# Memorandum

**TO:** Knoxville-Knox County Planning Commission  
**FROM:** Samiul Haque, Planner  
**DATE:** February 5, 2026  
**SUBJECT:** Appeal of an administrative determination for a Middle Housing application  
**FILE #:** 2-D-26-0B; Agenda Item #16

This request is an appeal of a Planning staff determination for a Middle Housing application for a proposed 8-unit structure at 1216 Callaway Avenue (KnoxPlans project # IRC-NEW-25-0546). The subject property is located in the Mechanicsville neighborhood and currently accommodates a one-story single-family dwelling. The property is zoned RN-4 and is in the Traditional Neighborhood Residential land use classification. It has a lot size of 10,114 sq ft and a lot width of 75 ft.

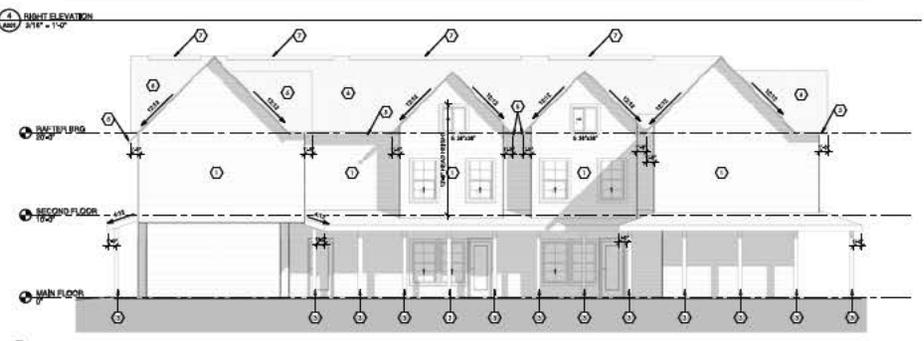
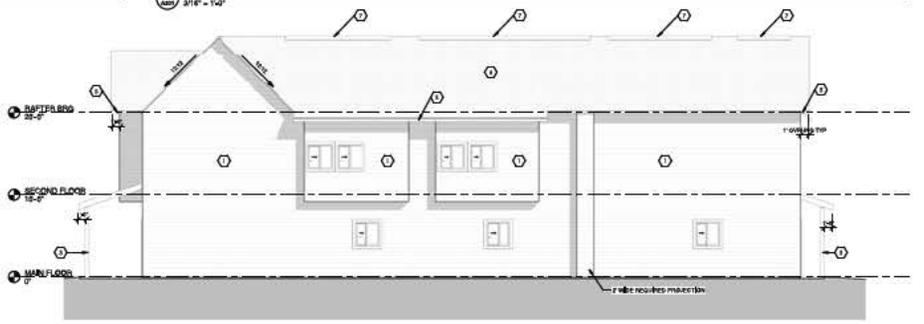
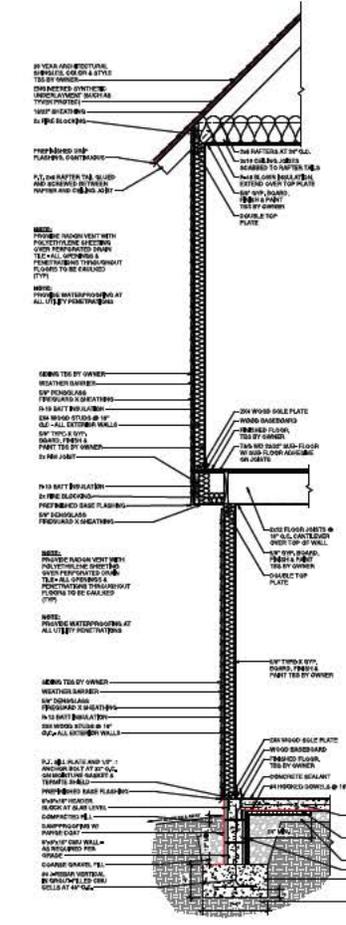
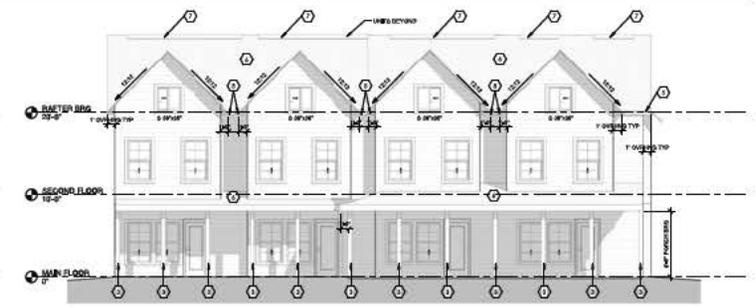
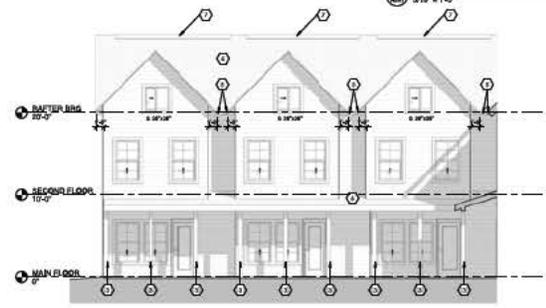
Ref.# 32	Planning Review	Samiul Haque	8/6/25 1:40 PM	Cycle 1	<i>Type your response here.</i>
	Unresolved	PLANNING -- Article 4.6.A (Middle Housing Types): The building is described as a multiplex. The application does not propose units that are arranged side-by-side and/or stacked with a shared entry on the ground floor, with building footprint and overall scale comparable to single-family houses, and does not meet the intent of the definition of multiplex. The building features eight units with individual entrances, with the units separated by party walls/shared side walls, which partially meet the definition of a DwellingTownhouse per article 2.3.

Comment					
	Ref.# 35	Planning Review	Samiul Haque	8/6/25 1:42 PM	Cycle 1	
	Resolved	QUESTION FOR ZONING: The second-story projections on the northern side (right elevation) encroach into the required 5' side setback. Am I right to assume these will not be allowed per Article 10.4?

Comment					
		<p><i>Reviewer Response: Samiul Haque - 10/8/25 3:05 PM</i> Revised plans not submitted.</p> <hr/> <p><i>Responded by: MARLOW BUILDERS - 9/30/25 12:14 PM</i> This design--namely shared walls with no common entry--was approved by Planning Commission on 14 August 2025, Agenda Item 30, Vote 10-1. That appeal dealt with the definition of MULTIPLEX and determined that this design--shared walls and no common entry--to comply. Accordingly, no further appeal is necessary. Additionally, at that hearing Planning Staff, including Director Brooks, made the argument about intent HOWEVER Planning Commission rejected that argument 10-1. Planning Staff is attempting to relitigate already decided designs.</p> <hr/> <p><i>Reviewer Response: Samiul Haque - 9/12/25 4:10 PM</i> The project as presented does not meet the intent of Middle Housing Standards and contradicts the following sections of the Zoning Ordinance.</p> <p>-- "promote the development of neighborhood-scale housing forms which are compatible with existing housing in the surrounding area." (Article 4.6 - Middle Housing Standards, Article 4.6.E.1 - Middle Housing Design Standards)          -- "generate new Middle Housing buildings that are similar in footprint, height, and setbacks with the existing neighborhood." (Middle Housing Design Standards, Article 4.6.E.4)          -- "the intent of Article 4.6 is to allow middle Housing types which are in harmony with the surrounding neighborhood and will not be injurious to it or the public welfare." (Administrative Variations, Variances, and Appeals, Article 4.6.G)</p> <p>The application generates a housing form that does not meet the intent of the Multiplex (small) type, which is to create neighborhood-scale, multi-unit buildings compatible with the existing neighborhood. The large, asymmetrical, U-shaped design with a continuous, 2.5-story mass fails to create the incremental scale transition between single-family homes and larger multifamily structures. It is not a neighborhood-scale housing form found in the surrounding or broader TDR area.</p> <p>Please revise the plans to meet Article 4.6. Alternatively, you could develop the property under the base RN-4 district standards (Article 4.3) or Cottage Court standards (Article 4.7).</p> <hr/> <p><i>Responded by: MARLOW BUILDERS - 9/3/25 8:42 PM</i> The definition of a multiplex does not require units to be stacked; nor does it require a shared entrance. This design complies with the building width and depth for a MULTIPLEX as specified in Art. 4.6. Planning Commission determined this design met the requirements of Art. 4.6 as a MULTIPLEX upon appeal of similarly designed structure located next door at 1214 Callaway Street, file number 8-B-25-OB, Agenda Item 30, heard by Planning Commission on 14 August 2025; vote approving this design as MULTIPLEX 10-1. See <a href="https://www.youtube.com/watch?v=nI2UodcbZEo&amp;list=PLHG8_5NdPaHaPC8FQ_0UBHKx3g1VzxBFc">https://www.youtube.com/watch?v=nI2UodcbZEo&amp;list=PLHG8_5NdPaHaPC8FQ_0UBHKx3g1VzxBFc</a></p>

Comment	will not be allowed per Article 10.4?	
		<i>Reviewer Response: Samiul Haque - 9/12/25 12:57 AM</i> The revised plan submitted on 9.3.2025 meets the required side setbacks.
